PERMIT

SEWAGE DISPOSAL SYSTEM

A REPAIR

SUBDIVISION WALFIELD ESTATES LOT 24A SECT 5 ROAD 3305 Stapleton Drive

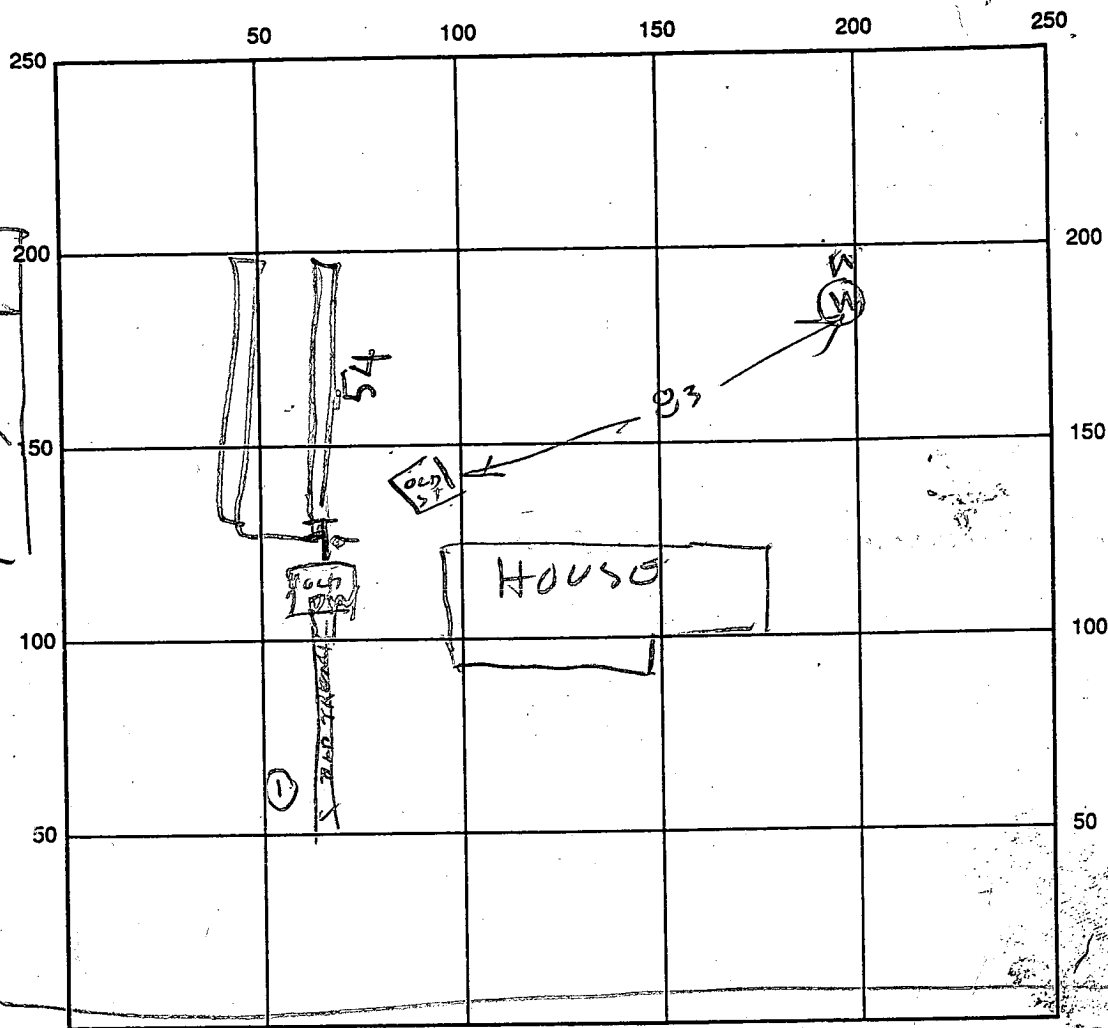
REPAIR - DRYWELL IS FULL. CALL FOR INSPECTION WHEN GROUND IS OPENED SO SANITARIAN CAN RECOMMEND REPAIR

5/20/91 TRENCH OFF OLD DRY
WELL 500 SQ FT 10 FT DEEP
5 FT STONE. RUN TOWARD BACK LANE
BJ

REMARKS: 5/28/91^{AM} SOIL GOOD TRENCH #1 ALMOST FINISHED TRENCH #2 STARTED BK
5/28/91^{PM} - TRENCH #1 FINISHED TRENCH #2 FINISHED TRENCH TO BE MADE A LITTLE LONGER TO USE UP STONE BK

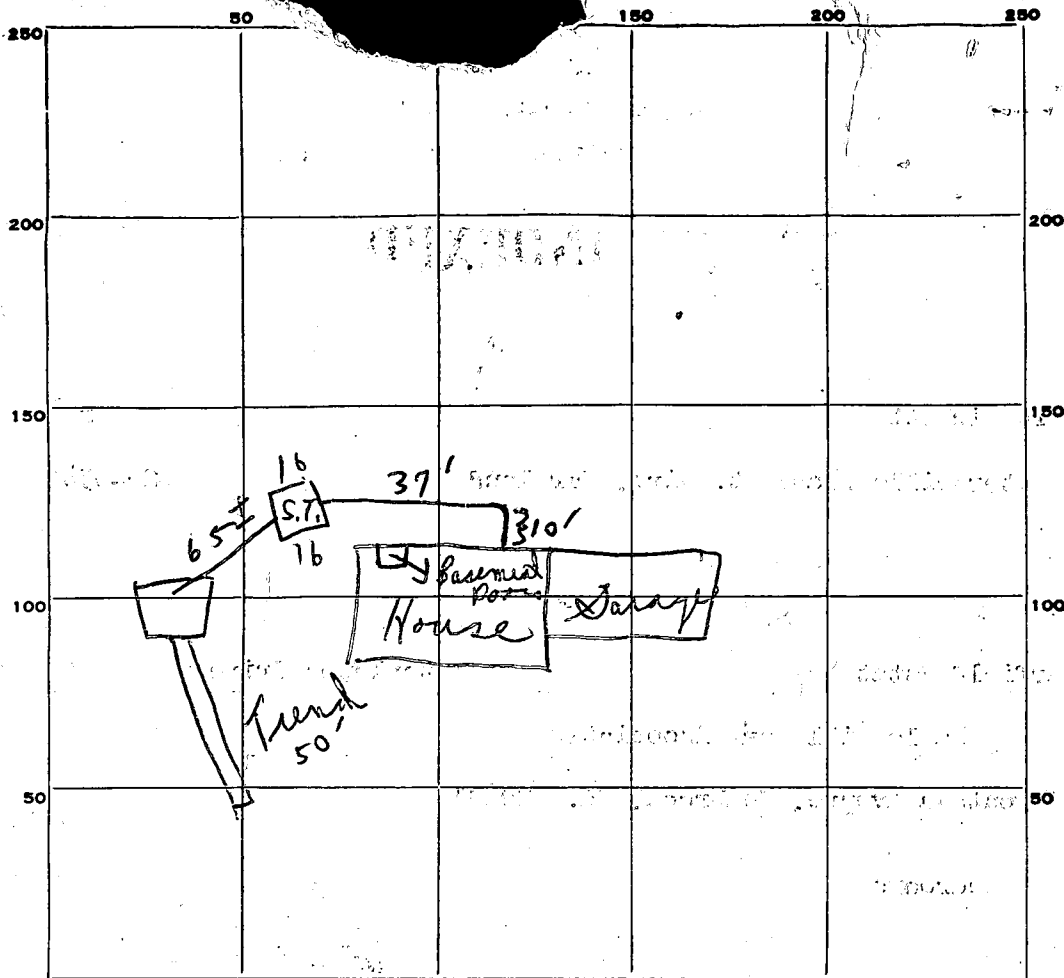
7/5/73 ↔ 7/3/73 Trench checked by Mr. Monaghan per Mr. Pickett's discussion on site at 7/5/73 inspection

Also per yellow card 7/5/73 (1) Trench

in - cast iron needed from S.T. to D. Well. & Cleanout needed. (2) System ok'd for back filling except

for cleanout on Dry Well - needs this (3) Cleanout

7/3/73 inspection
trench
Part of job done

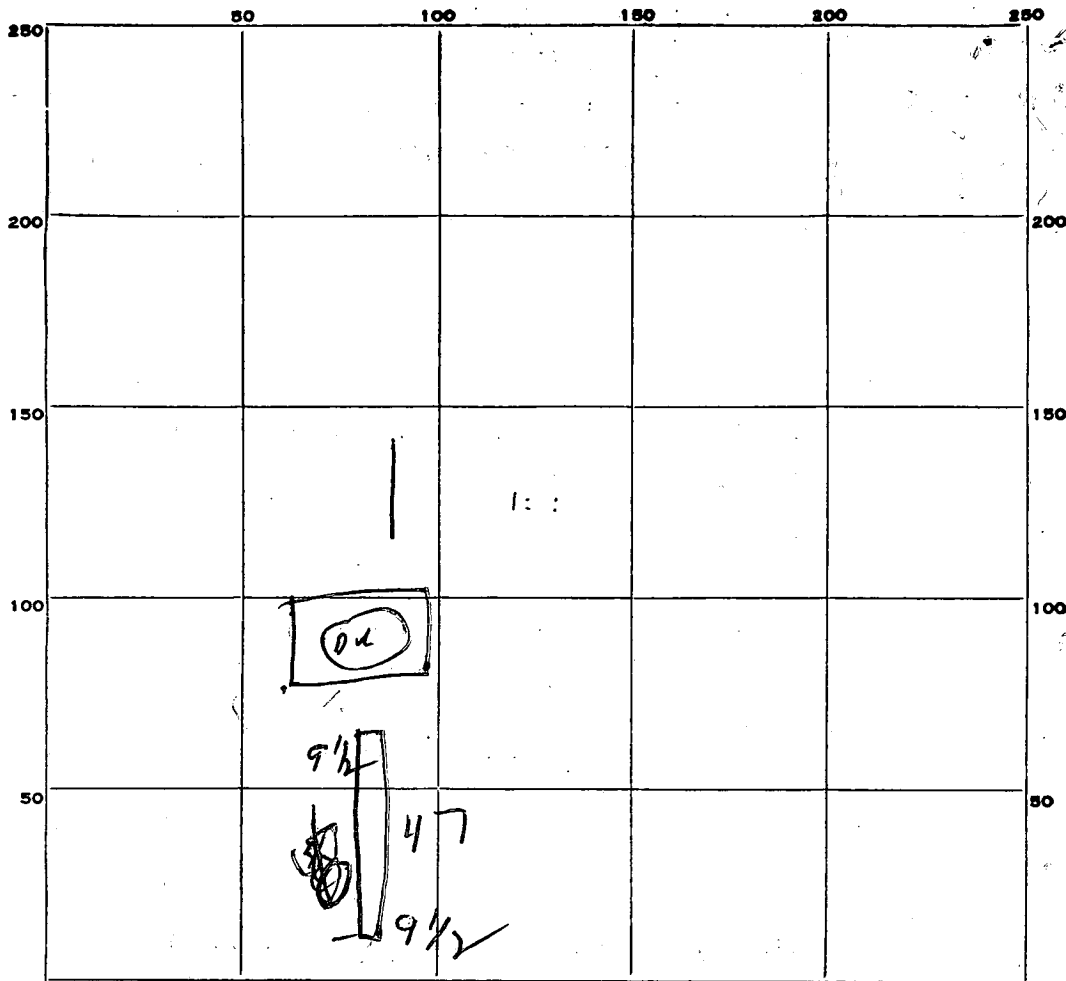
REMARKS ~~7-3-73 OK trench was to be 11' with sed mat.~~
 7-3-73 OK to put gravel in trench - but must 3 ft to trench
 to make 50'
